**OHIO TURNPIKE AND
INFRASTRUCTURE COMMISSION**

ADDENDUM NO. 1
ISSUED APRIL 15, 2020

PROJECT NO. 70-20-01 (RE-BID)
SLOPE REPAIRS
MILEPOST 132.6 WB
LORAIN COUNTY, OHIO

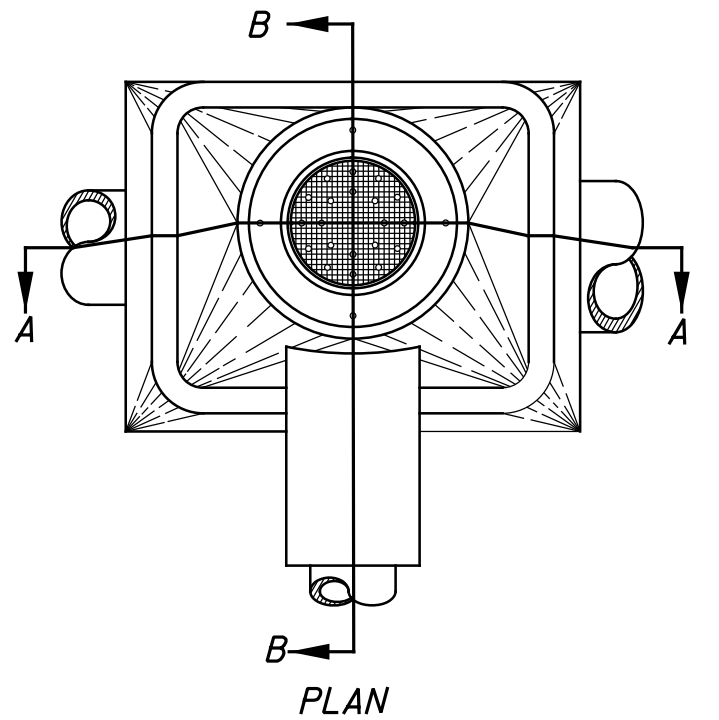
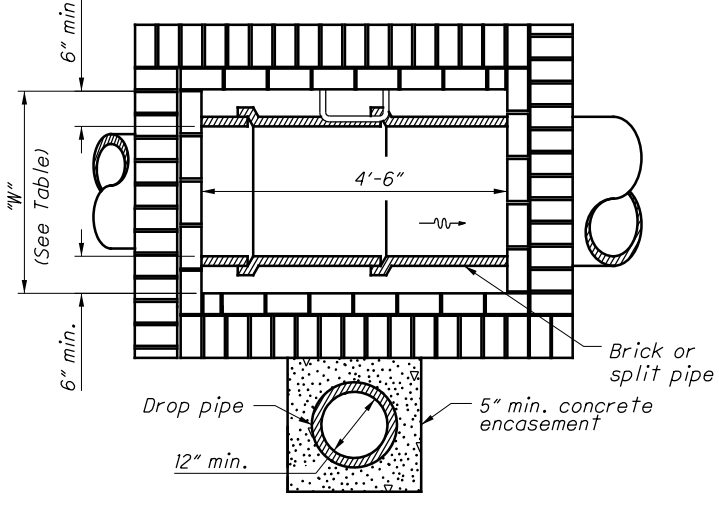
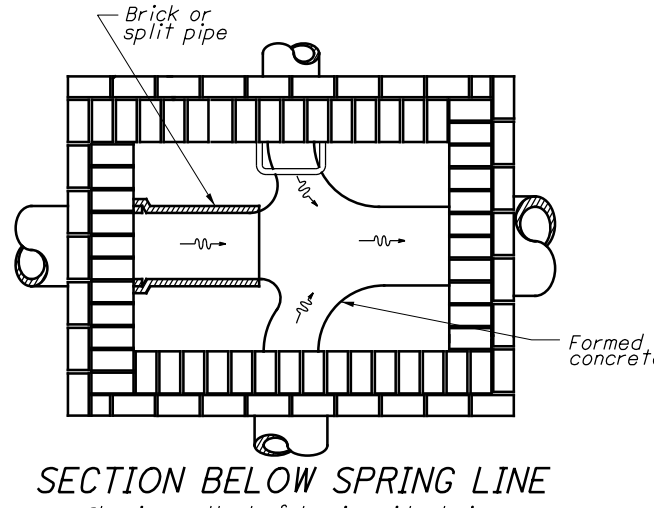
Q#1 Do you have a detail of the drop pipe required in the manhole at Sta 8+82.4 ? What size is the drop pipe inside the structure ?

A#1 Plan sheet 16 of 20 indicates that the structure at station 8+82.4 shall be a Manhole No. 3 with Drop Pipe. ODOT Standard Drawing MH-1.2 (1-15-16) for a Manhole No. 3 directs readers to ODOT Standard Drawing MH-3.1 for details on the construction of a Drop Pipe. A revised title sheet and ODOT Standard Drawing MH-3.1 (1-18-13) are provided with this Addendum.
